Re: Re-notification of proposed residential development

Proposal: Construction of a multi-dwelling housing and dual occupancy development containing 6 x 1-bedroom; 10 x 2-bedroom and 2 x 3-bedroom dwellings, with associated landscaping and fencing, surface parking for 20 cars and consolidation into 2 lots.

NSW Land and Housing Corporation
Multi-dwelling housing proposal, at
10 Lagoon Street and 75-77 Murray Street, Moruya NSW 2537

NSW Land and Housing Corporation
Multi-residential housing proposal
10 Lagoon Street and 75-77 Murray Street, Moruya NSW 2537

Figure 1: Zone of Influence

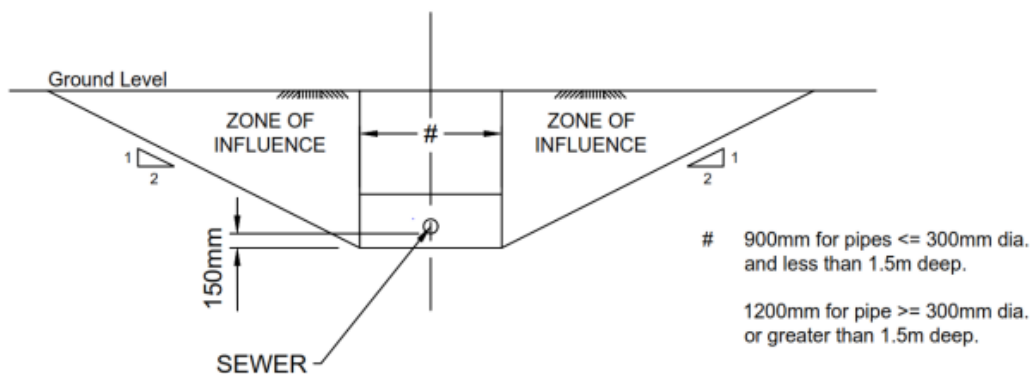
- Provide detailed design plans for sewerage including extension of the existing main on Lagoon Street by approximately 18m. Terminate with a new Manhole and stub with end cap for future extension.
- Designs prepared by a suitably qualified structural engineer for special footing adjacent to Council's sewer main. The design is to be consistent with Council's [Build in the Vicinity of Sewer Mains Code](#) (particularly Figure 1 below). Attached is a sewer diagram and the relevant manhole levels for the required engineer's footing design, adjacent to Council's sewer line.
